Planning, Zoning & Building Department

BOARD ACTION REPORT – APPEALABLE ITEM

Project Name: Patio Beach Delray
Project Location: 303 Gleason Street, Unit 6
Request: Class III Site Plan Modification, Landscape Plan, Architectural Elevations

Board: Site Plan Review and Appearance Board
Meeting Date: January 11, 2017

ELEVATIONS

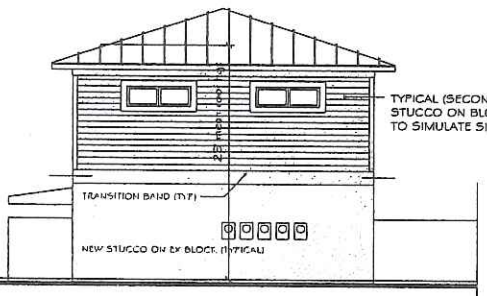
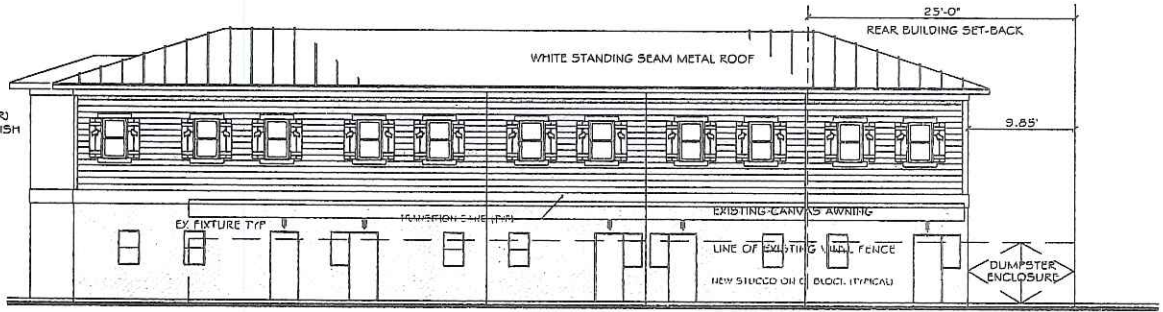
The Board voiced concerns with inconsistencies on the north elevation and window patterns with the floor plan. The Board added two new conditions for the Site Plan and Architectural Elevations as follows:

That the architectural elevations are revised to correspond to the building floor plan and that the changes are worked out with staff.

ARCHITECTURAL SITE PLAN
1"=50'-0" (TO MATCH ORIGINAL SURVEY)

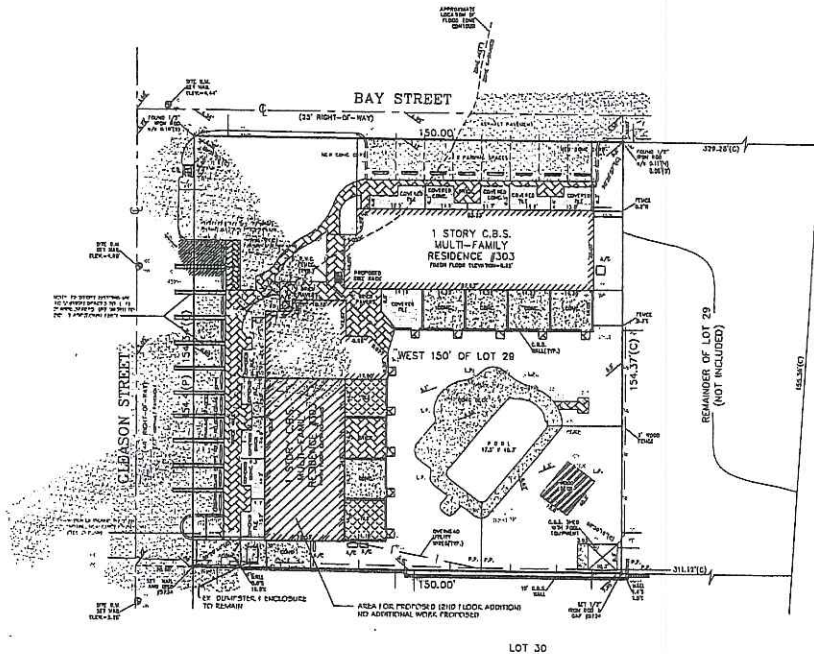
Site Plan: That the additional parking space located on Gleason Street is relocated to the western side on Bay Street and that the eight existing parking spaces are restriped to accommodate a handicap space to the west.
